i960[®] VH Embedded-PCI Processor

Specification Update

November 1998

Order Number: **273174-002**

Figure 1. DRAM RAS# Configurations

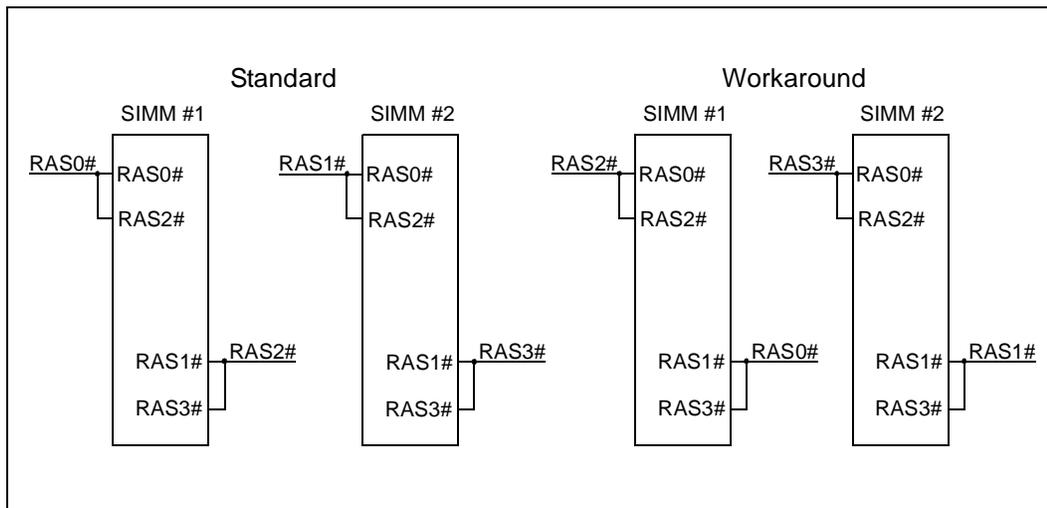
CASE 2 WORKAROUND - Initializing from 80960VH DRAM instead of FLASH/ROM

In a standard DRAM configuration, RAS0# and RAS1# are routed to the front sides of the SIMMs, and RAS2# and RAS3# are routed to the back sides of the SIMMs. To implement this workaround, swap RAS0# and RAS2# and swap RAS1# and RAS3#. This routes RAS2# and RAS3# to the front sides of their respective SIMMs, and routes RAS0# and RAS1# to the back sides of their respective SIMMs (See [Figure 1](#)). To determine which RAS# is asserted for a particular address and DRAM configuration, see [Table 1](#).

In an application using 4 Mbytes per bank/leaf and two single-sided SIMMs populated in a four bank design (total DRAM = 8 Mbytes), the following registers are set:

DRAM Bank Control Register (DBCR) = 0x0000 0013
 DRAM Base Address Register (DBAR) = 0xFE80 0000

The DBCR and DBAR values imply an address range of 8 Mbytes from 0xFE80 0000 to 0xFEFF FFFF.

When initializing from 80960VH DRAM, the first instruction fetch of the IBR is hard-coded to address 0xFEFF FF30; as a result, A23:22 = 11₂ and RAS3# is asserted. With the workaround in place, the RAS# lines are swapped and RAS3# is connected to the front side of the second SIMM and the IBR can be read.
